10.4. NSW Government’s Crows Nest Transport Oriented Development rezoning proposal

The purpose of this report is to make a submission to the Department of Planning, Housing, and Infrastructure on the Crows Nest Transport Oriented Development (TOD) rezoning proposal that is being exhibited for public comment between 16 July – 30 August 2024.

Figure K7.1. Right hand turn bans and the existing road network design will encourage rat-running through local streets.

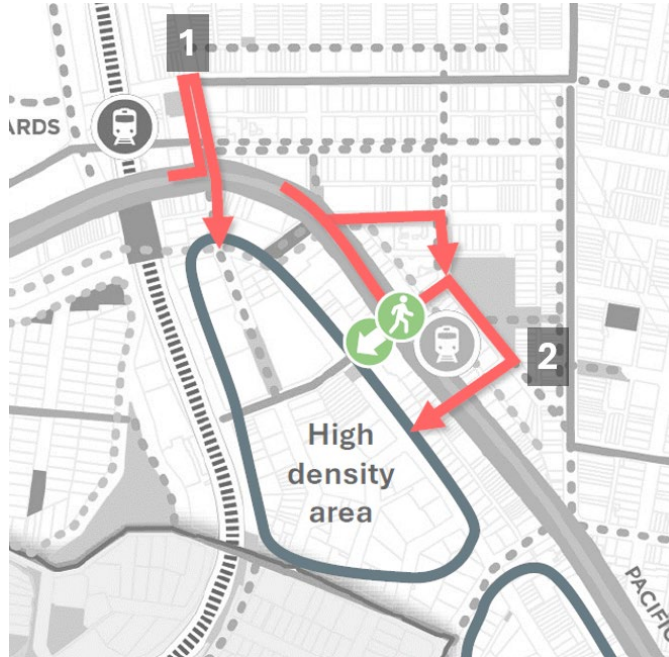
There are existing 'No Right Turn' restrictions for southbound traffic on the Pacific Highway into Hume Street or Shirley Street. Drivers travelling from the north to the proposed uplifted area on the western side of the Pacific Highway will attempt short-cut routes through residential streets to gain access (see Figure K7.1).

This is of concern particularly for the areas that are expected to experience increased pedestrian activity as a result of the Crows Nest Metro Station and increased traffic due to current and planned rates of off-street parking provision within new development. Potential amelioration measures that warrant investigation include:

- removal of the roundabout at the intersection of Chandos Street and Christie Street (identified as point 1 in Figure K7.1) to reduce this travel pattern.
- treatments to minimise through traffic on Hume Street crossing the Pacific Highway (identified as point 2 in Figure K7.1)
- traffic calming measures for the entire precinct to prevent short-cut through movements through local streets. This should include continuous footpath treatments and raised pedestrian crossings on Oxley Street and Clarke Street.
